# Access Compliance Report

### (Curb Ramps)

Intersection ID: 28945	Main Street: CRESCENT_VIEW_DR	Cross Street: MALLARD_CREEK_RD	Location: SE
ADA ID: C3B2CDE704E9	Ramp Type: Combination2	Initial Pass/Fail: Fail	Overall Compliance: No
Severity Score: 13.75			
Codes/Mitigation Info/Possible Solution		Field Measurements/Component Compliance

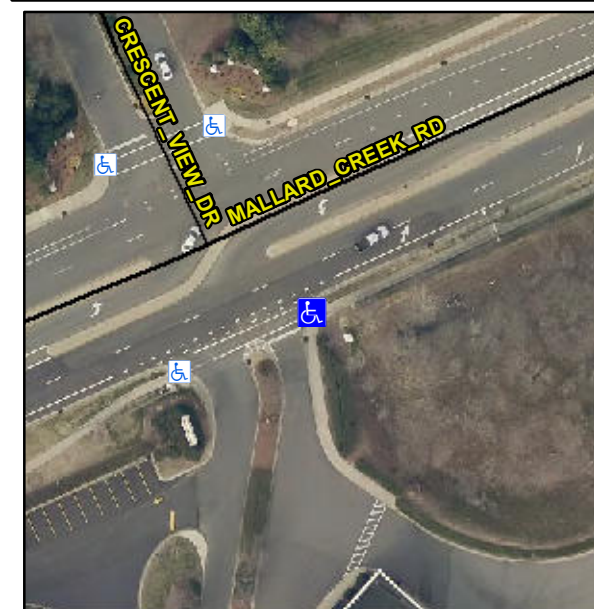
**Remove & Replace Entire Ramp.**

**R304.5.1, R304.5.1, R304.5.3,  
R304.3.2**
